ALERT SERVICE BULLETIN
Bell Helicopter **TEXTRON**
A Subsidiary of Textron Inc.

NO. 206L-06-141
DATE SEP 12, 2006
PAGE 1 of 10

MODEL AFFECTED: 206L SERIES

SUBJECT: HORIZONTAL STABILIZER 206-023-119-167,
INSPECTION AND REPLACEMENT OF

Figure 1 – Horizontal stabilizer, first inspection and 600 hour / annual inspection
(Sheet 1 of 2)

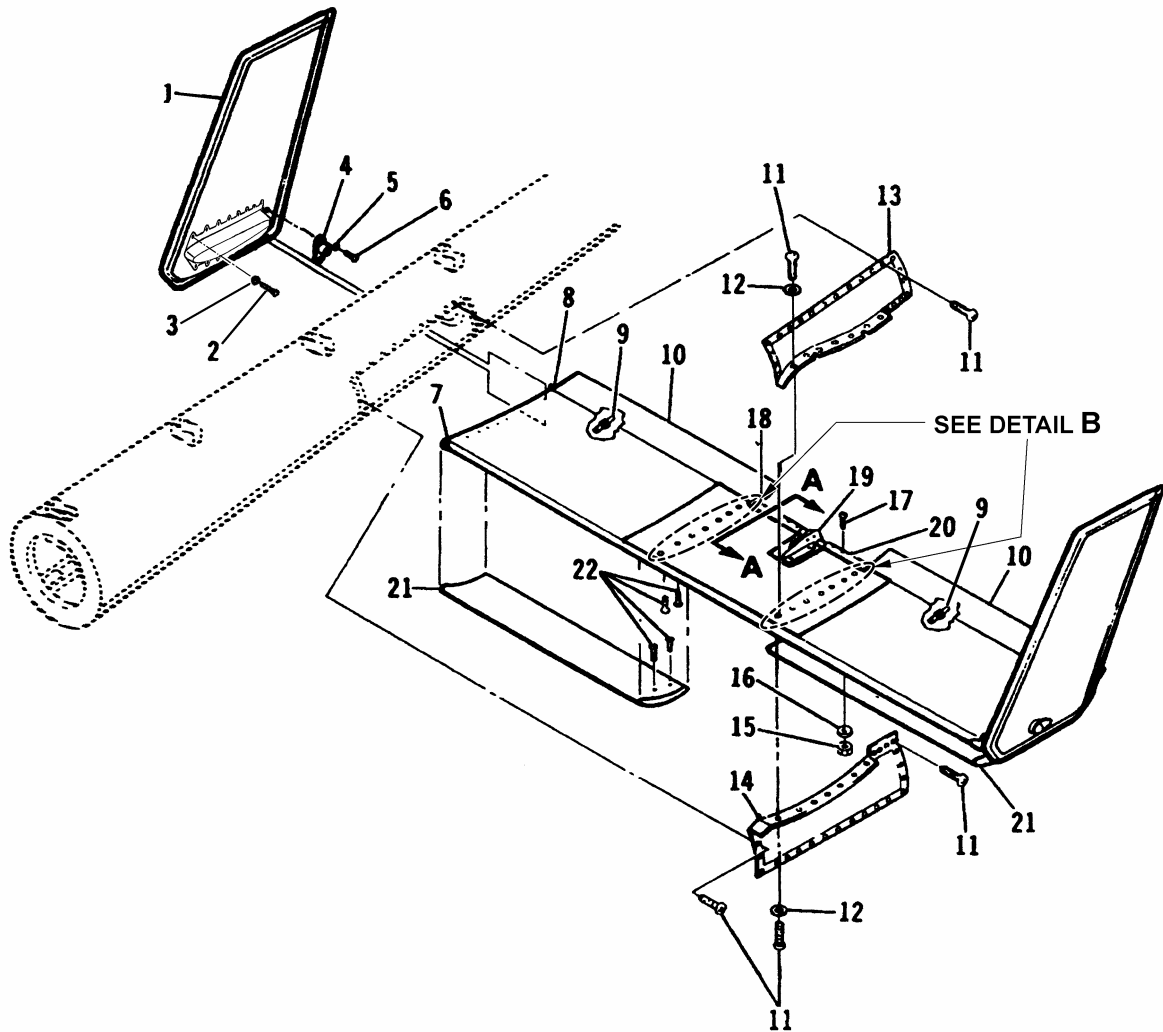
1. Determine if you have an affected horizontal stabilizer as listed in Table 1. Refer to Figure 1. Part number and serial number can be found on identification tag (30) that is located in the middle section of the trailing edge of the stabilizer (7).

2. Remove the screws (11) and the washers (12) from the L/H and R/H lower supports (14).
3. Remove L/H and R/H lower supports (14).
4. Remove screws (2) and the washers (3) attaching R/H finlet (1) to stabilizer (7).
5. Disconnect position light wiring and carefully remove R/H finlet (1) from stabilizer (7).
6. Remove nut (28), washers (27) and bolt (26). Detach control tube (29) from horn (19).
7. Remove the three screws (23) and washers (24) from support (32).
8. Remove the two screws (6) and washers (5) from the L/H fitting (4). Removal of the fitting (4) will allow the L/H and R/H elevator to move backward as an assembly and permit its removal without the requirement to remove the L/H finlet (1).

9. Slide elevator (10) aft until it clears the two pins (9) and remove the L/H and R/H elevator (10) as an assembly.
10. Carefully remove the minimum amount of sealant covering the wiring and get access to the identification tag (30). Record the serial number.

1. Refer to figure 1. Inspect the horizontal stabilizer (7) as follows:

2. Remove the screws (11) and the washers (12) from the L/H and R/H lower supports (14).
3. Remove L/H and R/H lower supports (14).
4. Refer to Figure 1 Detail B. Clean and prepare lower surface of the stabilizer for inspection using cheesecloth (C-486) moistened with acetone (C-316).

5. Inspect stabilizer in area of the inserts (31), on the lower surfaces for cracks and deformation using a 10X power magnifying glass. Inspect the area around each inserts and between inserts for debonding using tap test method.

8. Remove the screws (11) and the washers (12) from the L/H and R/H upper supports (13).
9. Remove L/H and R/H upper supports (13).
10. Refer to Figure 1 Detail B. Clean and prepare upper surface of the stabilizer for inspection using cheesecloth (C-486) moistened with acetone (C-316).

11. Inspect stabilizer in area of the inserts (31), on the upper surfaces for cracks and deformation using a 10X power magnifying glass. Inspect the area around each inserts and between inserts for debonding using tap test method.

6. If any damage is found, the stabilizer is not repairable. Accomplish Part III immediately.
7. If no damage is found, reinstall L/H and R/H lower supports (14) with screws (11) and washers (12).

12. If any damage is found, the stabilizer is not repairable. Accomplish Part III immediately.
13. If no damage is found, reinstall upper supports (13) with screws (11) and washers (12).
14. Make an entry in the helicopter records to indicate that Part II of this bulletin has been accomplished and that a recurring 600 hour or annual inspection is required until Part III is accomplished.

1. Remove and retire from service affected horizontal stabilizer. Install a serviceable horizontal stabilizer in accordance with the appropriate Maintenance Manual and TB 206L-00-203 for stabilizer shimming procedure.
2. Make an entry in the helicopter records to indicate that this bulletin has been accomplished
